UNITED STATES PATENT AND TRADEMARK OFFICE

10/731,860	12/09/2003	Sei-Hyung Ryu	5308-278	4232
------------	------------	---------------	----------	------

Office Action Summary

DETAILED OFFICE ACTION

FIG. 1

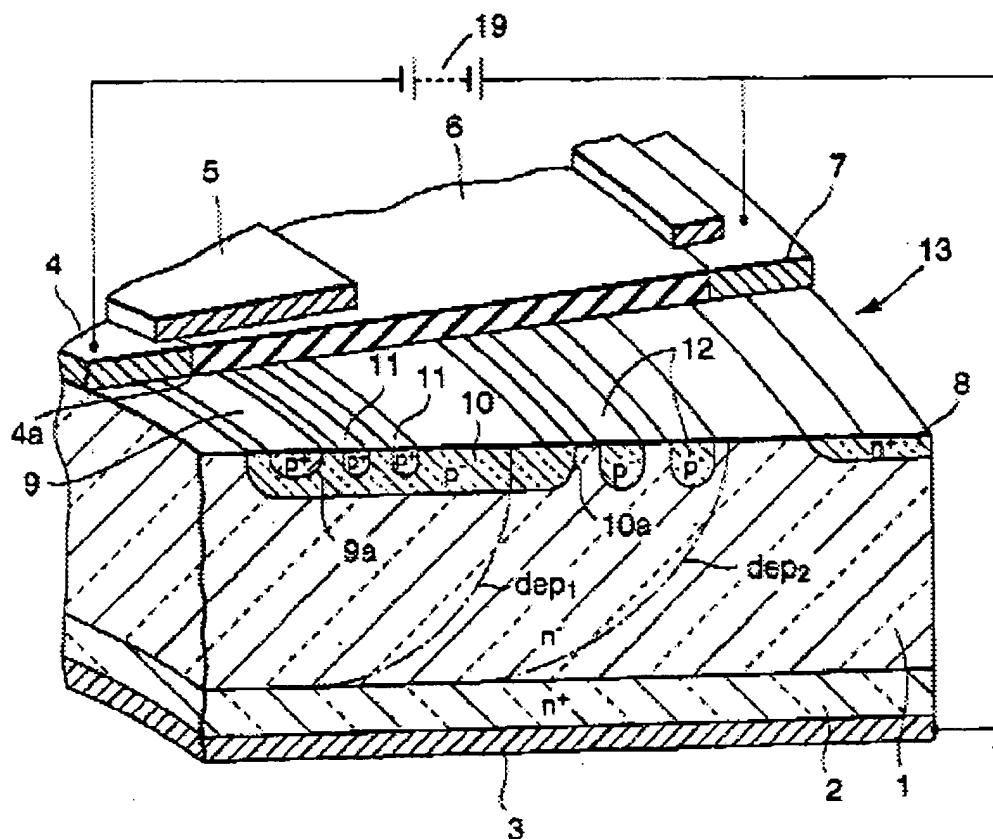
Kinoshita discloses (the abstract, fig 1, column 3 line 3) an edge termination structure for a silicon carbide semiconductor device, comprising: a plurality of spaced apart concentric floating guard rings (fig 1 layer 11) in a silicon carbide layer that at least partially surround a silicon carbide-based semiconductor junction; an insulating layer (fig 1 layer 6) on the floating guard rings; and a silicon carbide surface charge compensation region (fig 1 region 10) between the floating guard rings and adjacent the insulating layer or an edge termination structure for a silicon carbide semiconductor device, comprising: a plurality of spaced apart concentric floating guard rings (fig 1 layer 11) in a silicon carbide layer that surround at least a portion of a silicon carbide-based semiconductor junction; an insulating layer (fig 1 layer 6) on the floating guard rings; and means (fig 1 region 10) for neutralizing effects of charges at an interface between the insulating layer and the silicon carbide layer in the region of the floating guard rings.

Kinoshita discloses (the abstract, fig 1) an edge termination structure, wherein the surface charge compensation region 10 is doped lighter (p -) than the guard rings 9a (p +)

the surface charge compensation region (fig 1 region 10) extends completely between adjacent ones of the floating guard rings and comprises a single region that overlaps the floating guard rings.

Kinoshita discloses (the abstract, fig 1) an edge termination structure, wherein the silicon carbide layer is an n-type silicon carbide layer and the guard rings and surface charge compensation region are p-type silicon carbide.

Kinoshita discloses (the abstract, fig 1) an edge termination structure, wherein the the means for neutralizing comprises a surface charge compensation layer (layer 10) between adjacent ones of the guard rings.

FIG. 8

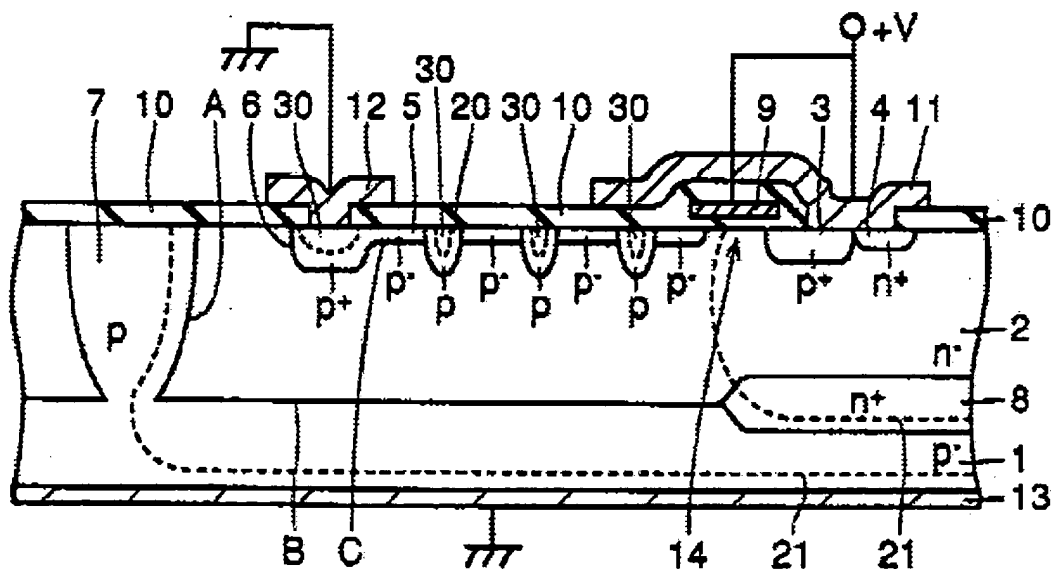
Akiyama discloses (the abstract, fig 8) discloses all the invention including charge compensation layers that has less depth than the ring layer except the specific teachings about using a Silicon Carbide substrate. This feature, however, is old and well known in the art because Silicon Carbide has been used in addition to Silicon as substrate for power device with improved performance in Semiconductor manufacturing

Akiyama discloses (the abstract, fig 8) discloses all the invention except going into details about the dose, the dimension and the numbers of the guard rings, etc. These features, however, are considered obvious since it has been held that where the general conditions of a claim are disclosed in the prior art, discovering the optimum or workable range involves only routine skill in the art.

Fig.2.

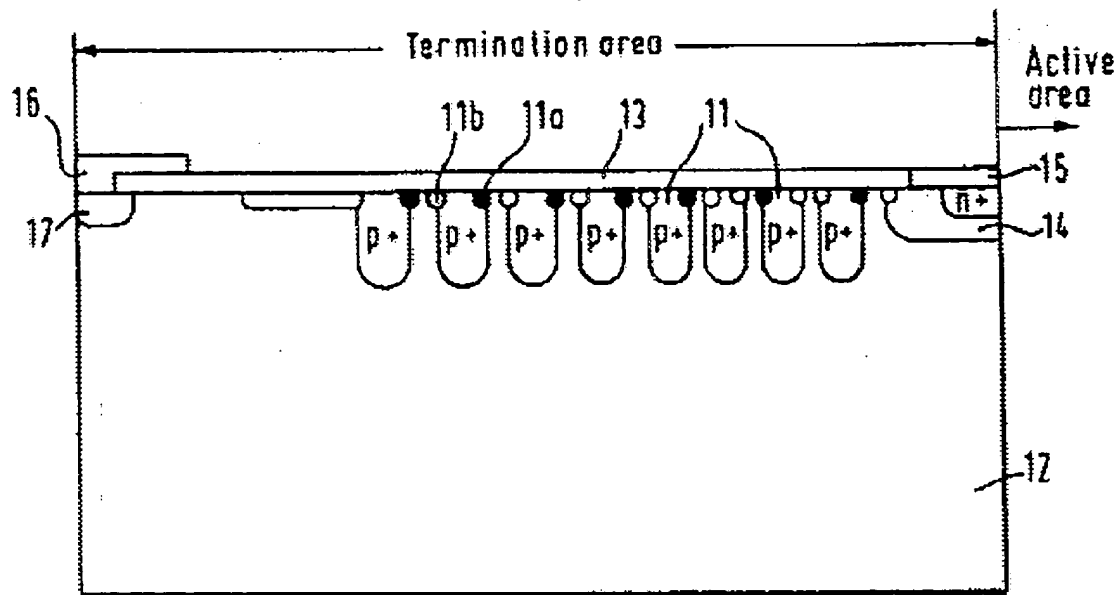
Trajkovic discloses (the abstract, fig 2) all the invention including the surface charge compensation region that extends between adjacent ones of the floating guard rings but does not extend completely between two adjacent floating guard rings except for specific teachings about using a Silicon Carbide substrate. This feature, however, is old and well known in the art because Silicon Carbide has been used in addition to Silicon as substrate for power device with improved performance in Semiconductor manufacturing.

Trajkovic discloses (the abstract, fig 2) all the invention including a plurality of compensation regions (regions 11 in fig 2) adjacent to the guard rings except for specific teachings about using a Silicon Carbide substrate. This feature, however, is old and well known in the art because Silicon Carbide has been used in addition to Silicon as substrate for power device with improved performance in Semiconductor manufacturing.
